SUNDRY NOTICES AND REPORTS ON WELLS

8. Well Name and No.
BILBREY 34/27 B2PA FED COM 1H

Mewbourne Oil Company requests approval to make the following changes:

**** BLM REVISED ** BLM REVISED ** BLM REVISED ** BLM REVISED ** BLM REVISED ****

10M BOPE & Closed Loop Equipment Schematic

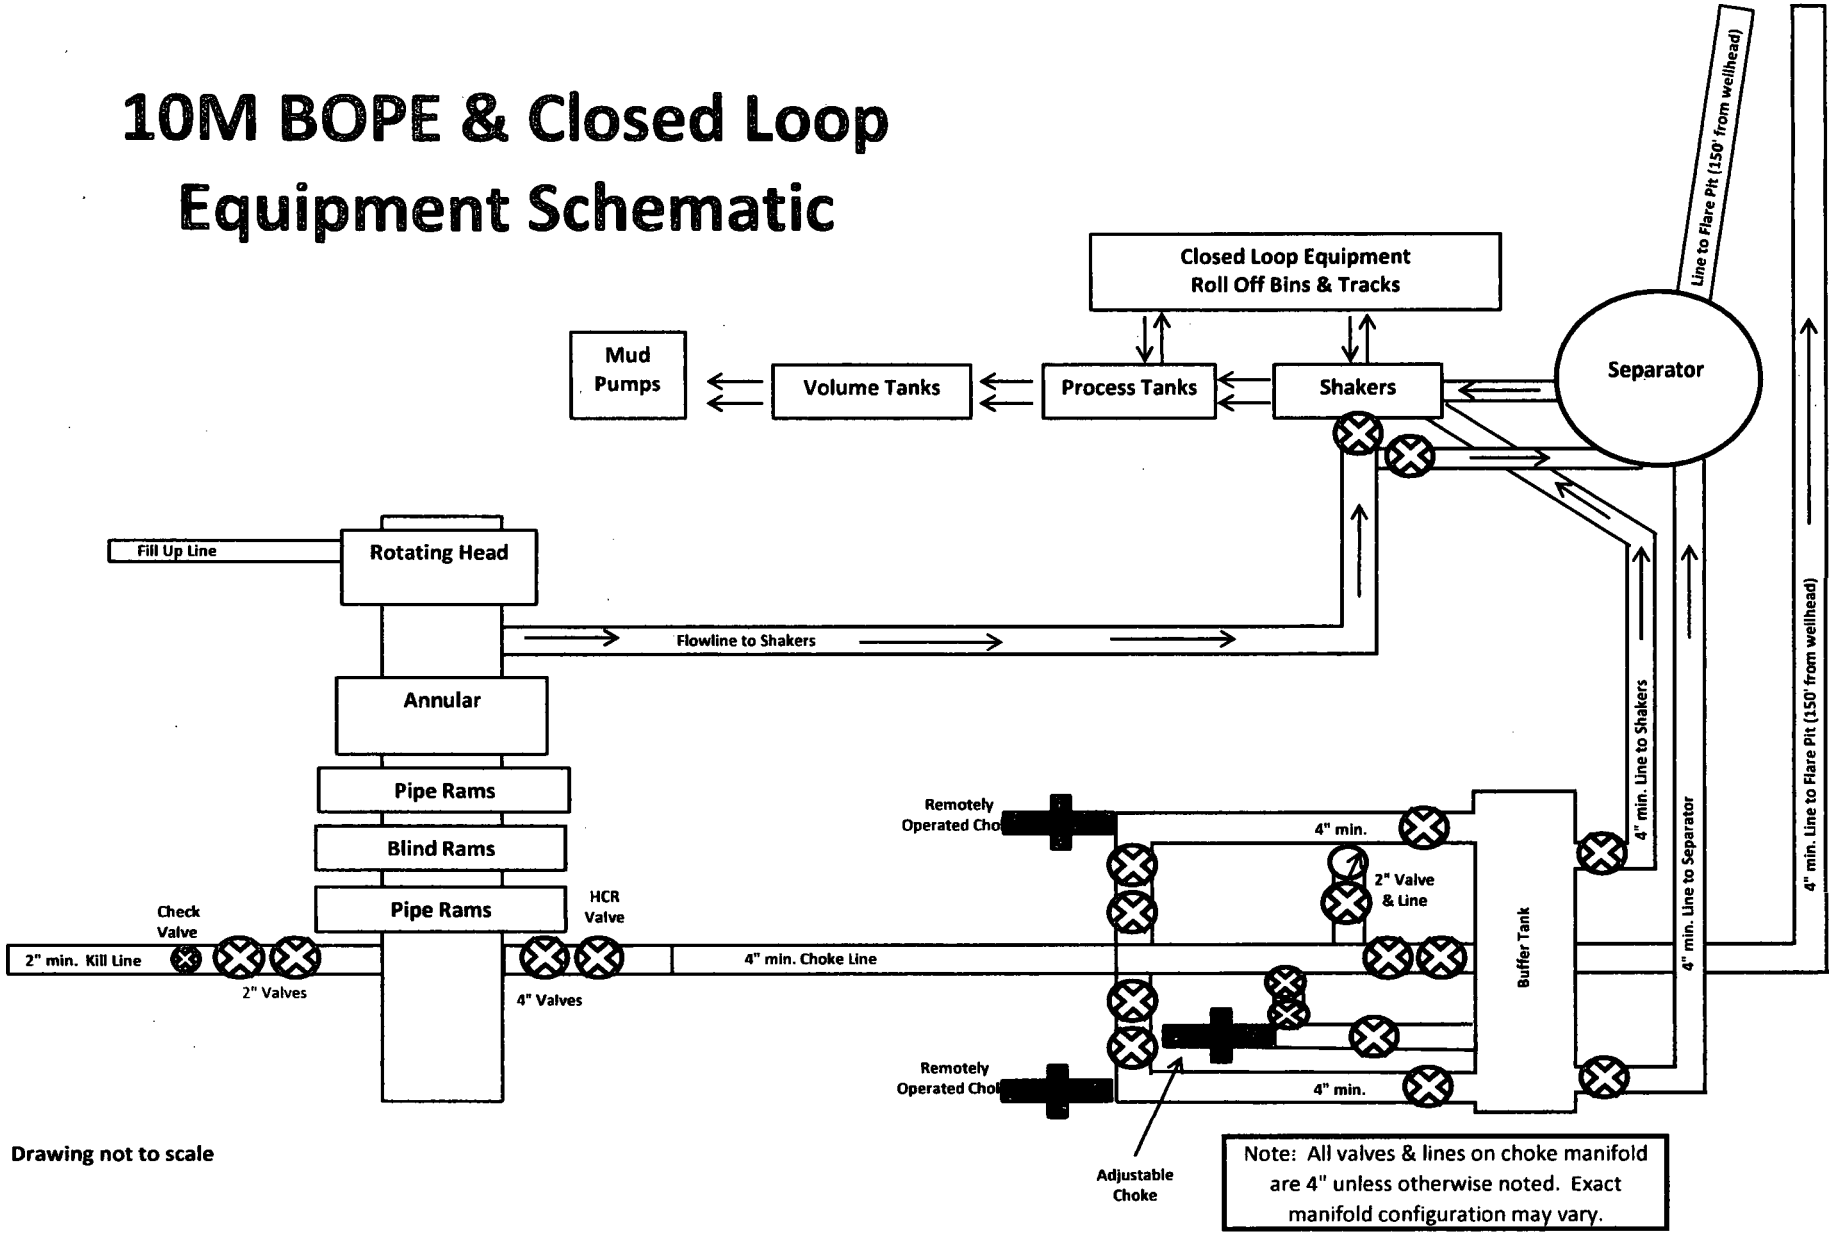
1) Change name to Bilbrey 34/27 W2PA Fed Com #1H. NEW PROPID (322268)
2) Change pool to ~~Bilbrey Wolfcamp Gas (72126)~~.
3) Change target zone to Wolfcamp @ 12,294' TVD.
4) Change casing & cmt to reflect new target depth.
5) Change BOPE to 10M.

Y	Variance: A variance is requested for use of a 5000 psi annular BOP with the 10,000 psi BOP stack. Please see attached description and procedure.

1. Variance approved to use flex line from BOP to choke manifold. Manufacturer's specification to be readily available. No external damage to flex line. Flex line to be installed as straight as possible (no hard bends).

2. Minimum working pressure of the blowout preventer (BOP) and related equipment (BOPE) required for drilling below the surface casing shoe shall be **10,000 (10M)** psi. **Variance approved to use a 5M annular. The annular must be tested to full working pressure (5000 psi.)**
